Well Name: NV NAVAJO 22	Well Location: T29N / R14W / SEC 22 / SWSW /	County or Parish/State: SAN JUAN / NM
Well Number: 3	Type of Well: CONVENTIONAL GAS WELL	Allottee or Tribe Name: SHIPROCK
Lease Number: 14206032199	Unit or CA Name:	Unit or CA Number:
US Well Number: 3004531046	Well Status: Producing Gas Well	Operator: HILCORP ENERGY COMPANY

Type of Submission: Notice of Intent

Type of Action: Plug and Abandonment

HILCORP ENERGY COMPANY
NV NAVAJO 22 3
NOTICE OF INTENT TO PERMANENTLY ABANDON

NV NAVAJO 22 3 - PROPOSED P&A SCHEMATIC

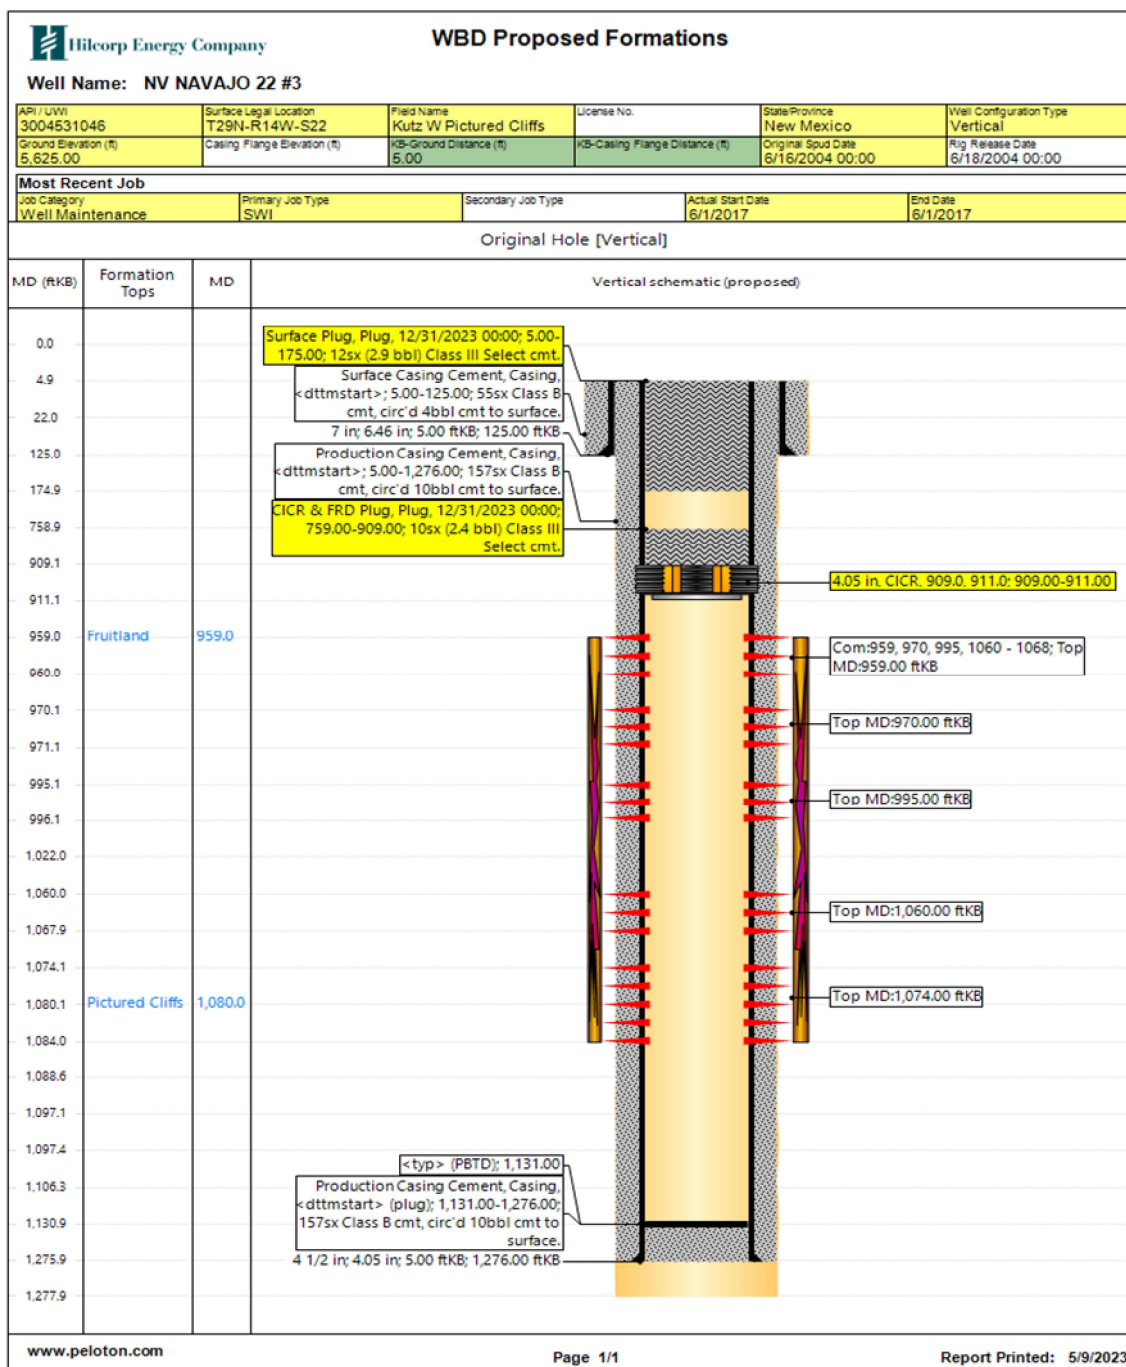
1. Plugging operations authorized are subject to the attached "General Requirements for Permanent Abandonment of Wells on Federal and Indian Lease."
2. The following modifications to your plugging program are to be made:
 - a. Adjust Plug #1 to cover BLM Fruitland formation top @ 706'.
3. Farmington Office is to be notified at least 24 hours before the plugging operations commence at (505) 564-7750.

- Pictured Cliffs perms 1074' - 1084'. Fruitland coal perms 959' - 1068'.	1) Formation Tops Same
- Adjust Plug #1 to cover BLM Fruitland formation top @ 706'.
